STAFF REPORT and NOTICE OF DECISION

Les Schwab Site Plan and Short Plat
Project No. PLZ-22-0095-0096 (Master-22-0064)

SITE PLAN

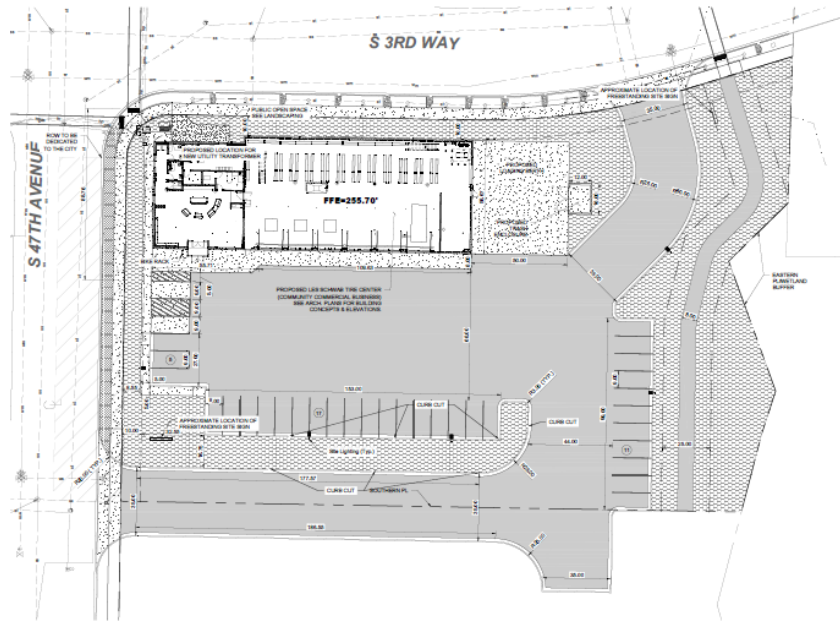
The applicant has provided pedestrian connections on the west side of the site; however, another connection shall be added to the east of the site from the parking area connecting to the walkway in front of the building.

Staff finds that internal and external pedestrian connections provide access between the building entrances, parking areas, and public rights-of-way via the most direct routes; however, an additional pedestrian connection shall be provided from the east parking area to the walkway to the entrance of the building.

The applicant will need to add a pedestrian path connecting the parking on the east side to the front of the building.

The applicant will need to show how these items have been addressed from the parking area on the east side of the site to the building entrance walkway. As a **condition of approval**, the applicant shall submit a plan that demonstrates compliance with RDC 18.720.040.C.5, prior to final engineering approval.

Opposing driveway alignments are not shown on the plan, driveway alignment could not be verified.

As a **condition of approval**, the applicant shall demonstrate compliance with the pedestrian connectivity requirement in RDC 18.230.050.D.2 and 18.230.050.D.4.f and g prior to final engineering approval.

As a **condition of approval**, the applicant shall demonstrate compliance with the pedestrian connectivity requirement in RDC 18.230.050.D.2 and 18.230.050.D.4.f and g prior to final engineering approval.

Staff finds that the proposed preliminary plan meets standards for road widths on all streets, however driveway alignment was not shown and could not be verified. As a **condition of approval**, the driveways shall be aligned with existing driveways on the opposite side of the street or shall be a minimum of 100 feet from any intersection.
